**Re: Renewal of mining permit for Cayuga Salt Mine**

October 9, 2017

September 2016 Map:

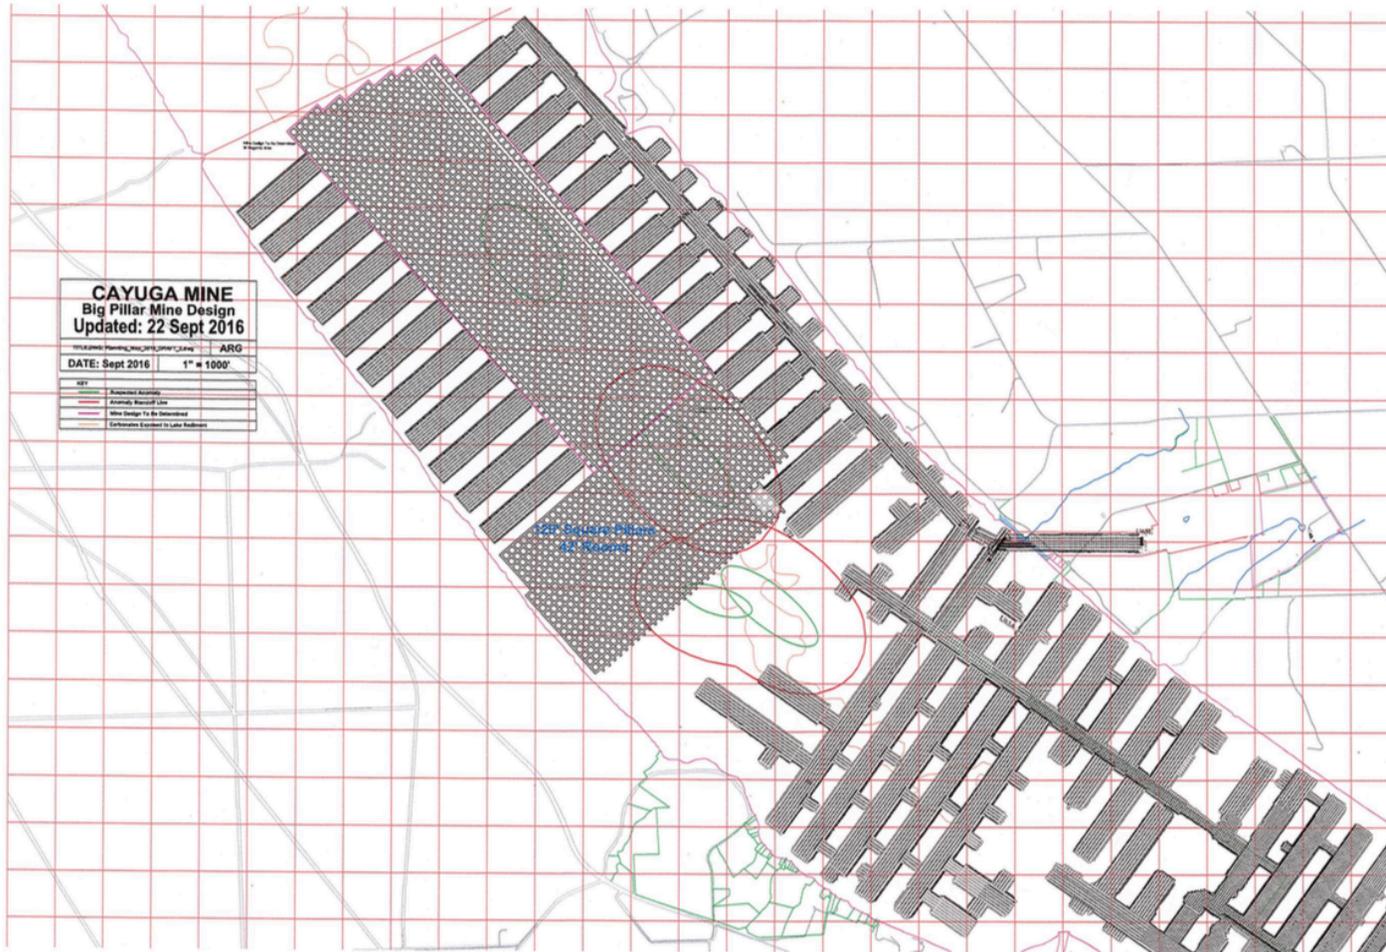
Regarding the two Cargill maps which have a representation for the setback zones using an indicative oval for what we understand to be the Frontenac Point Anomaly (FPA), on the September 2016 map (Attachment A) we see that half of Panel 66 (an offshoot of Panel NW2) violates the setback zone as does half of Panel 62A. And, yet on Cargill’s February 2017 map (Attachment C) the blue oval surrounding the “FPA + 1000” no longer touches either Panel 66 or Panel 62A. The re-drawing and removing of a setback oval is troubling. DEC’s mining consultant, Vincent Scovazzo of John T. Boyd Company, appended to his review of Cargill’s 2015 Annual Report to DEC e-mails dated Feb. 2, 2016, between DEC officials Chris Lucidi, Steve Army, Matthew Podniesinki, and Simone S Rodriguez in which they acknowledge that

Cargill's Panel NW2 had indeed violated the 1000' setback associated with the Frontenac Point Anomaly. This would indicate that the ovals and setbacks present in the September 2016 map are a more accurate than the changed representation of the FPA +1000 ft in the February 2017 map.

Clearly shows anomalies (green ovals) with defined 1000 ft setbacks (red ovals); also shows “carbonates exposed to lake sediments” (difficult to see orange lines)

Cargill's Nov 2016 Three-year Mine Plan Map

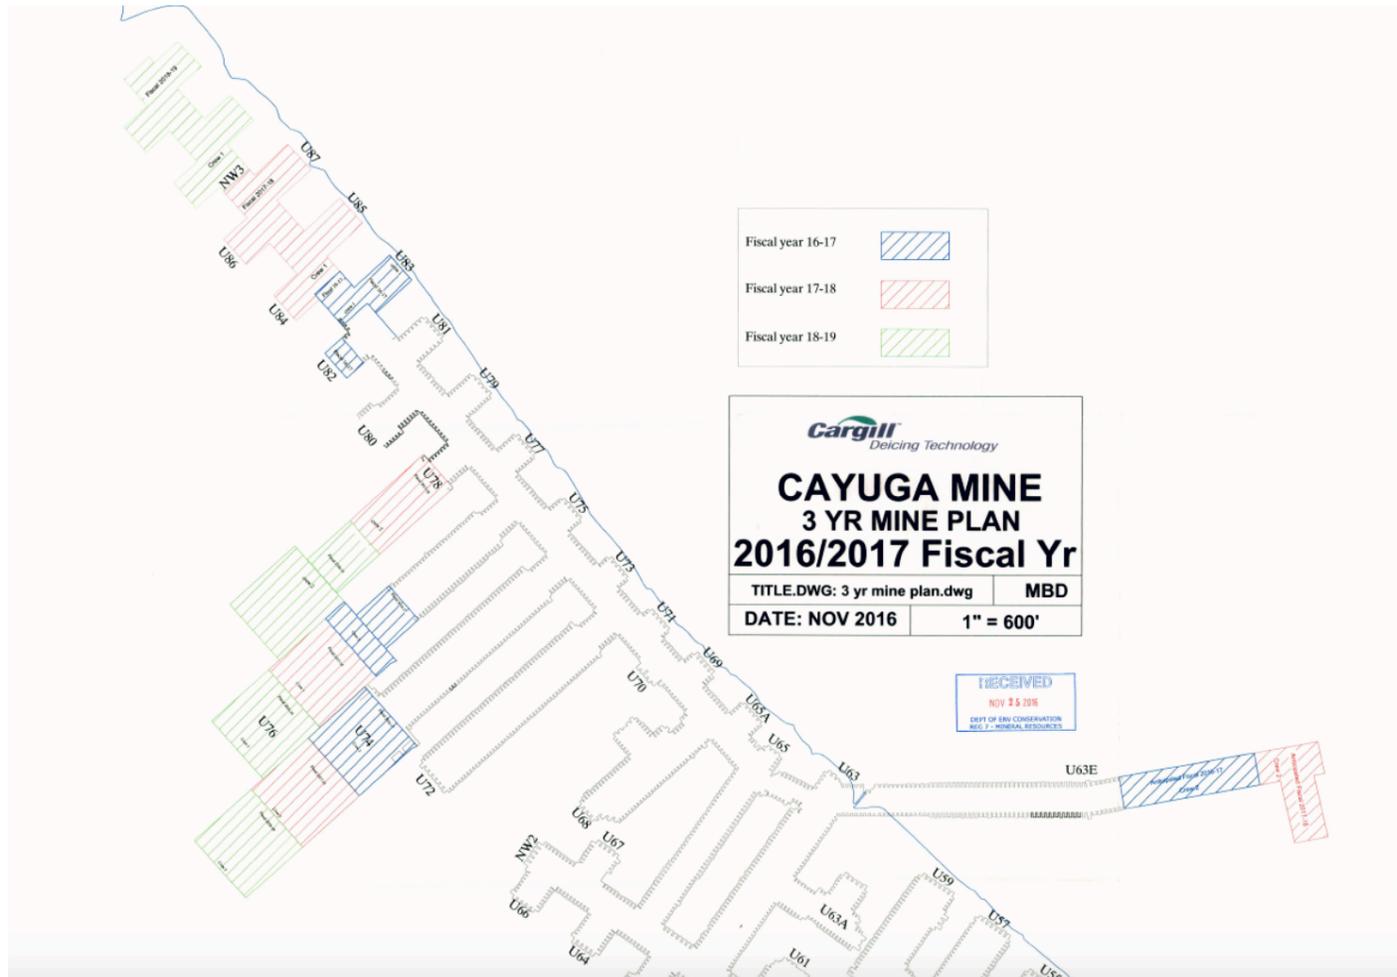
No mention of Frontenac Point Anomaly (FPA) and required setbacks

Cargill's Feb 2017 Three-Year Mine Plan Map

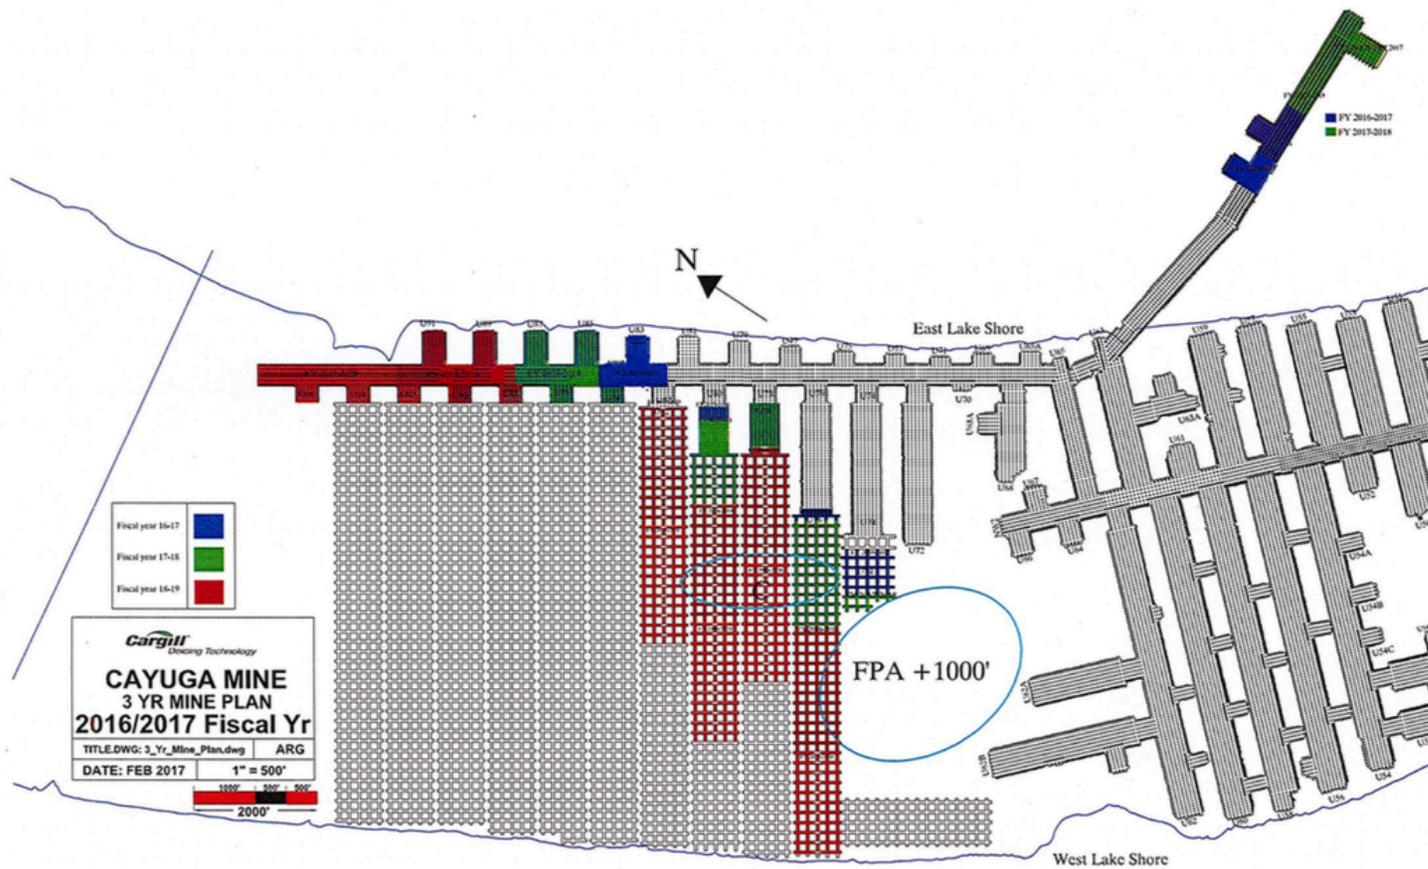
FPA + 1000 ft setback is shown however the indicated area is now significantly smaller than the area indicated in the Sept 2016 map presented in Attachment A.

If mining setback presented in the September 2016 map had been observed then Planned (or completed mining) in Fiscal years 16-17 and 17-18 would be in violation of those setbacks.
